Addendum to the Final Environmental Impact Statement - Baffinland Response to Technical Comments November 15, 2013		
Qikiqtani Inuit Association		Baffinland's Response
Number	Recommendation	
Note: See Baffinland Response to Project Certificate 005 Amendment Considerations attached for suggested word changes and new conditions; also see Appendix A,where referenced, for more detailed responses to technical comments.		
FM-01	It is recommended that dust dispersal modeling be revisited to reduce uncertainty and inform monitoring. The quantity and chemical composition of dust entering aquatic systems should be monitored to ensure that mitigation measures are effective. Sediment impact thresholds should be established for Arctic char, and possibly other taxa, to inform impact assessment, monitoring, and mitigation.	<p>Dust dispersion modelling presented in the FEIS was “worst case” as it involved highly conservative assumptions and no dust controls. The FEIS Addendum considered dust controls and other refinements to the model. This is the reason for the reduction in dust deposition despite the overall tonnage increasing with the ERP from 18 to 21.5 Mt/a.</p> <p>Nonetheless, a comprehensiv

Figure 1: Caribou decision tree

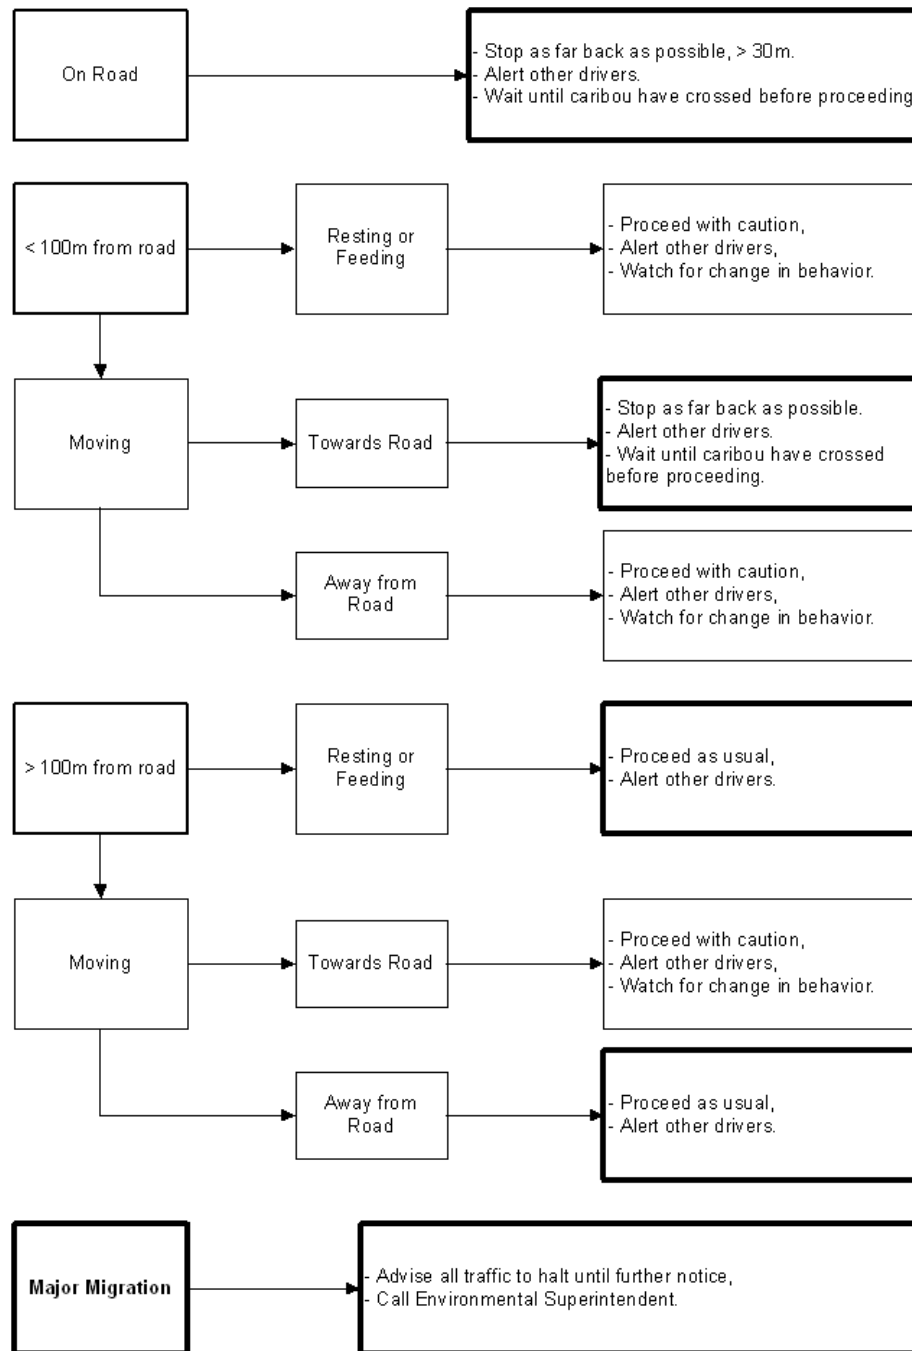
The Proponent must re-evaluate the potential impact on caribou movement of upwards of 200 trucks per day, the majority of them haul trucks, travelling along the Tote Road for the life of the mine. This re-evaluation should include revisions to the mitigation and adaptive monitoring plans and an assessment of residual impacts after mitigation.

The Roads Management Plan should specify how caribou presence on and in the vicinity will be monitored and what thresholds (other than the tracks) will be used to trigger specific levels of traffic management. Baffinland should investigate dash camera technology and wildlife road surveillance systems to prevent collisions and use remote camera monitoring to describe caribou use of the road corridor.

- Modified embankment heights and finer fill material at trails that cross the road (e.g., caribou crossings);
- Snow bank height maintained at less than 1 m;
- Operator radio communication as an early warning of caribou to approaching vehicles;
- Road signage identifying known crossing areas;
- Wildlife right-of-way policy; and
- Implementation of the caribou decision tree (see attachment).

QIA's suggestion for dash-mount cameras is not being considered as a monitoring tool. Communication among drivers, check-in at gates for wildlife observations, height-of-land surveys and follow-up investigations of all mortality events are sufficient to monitor and mitigate potential effects on caribou movement.
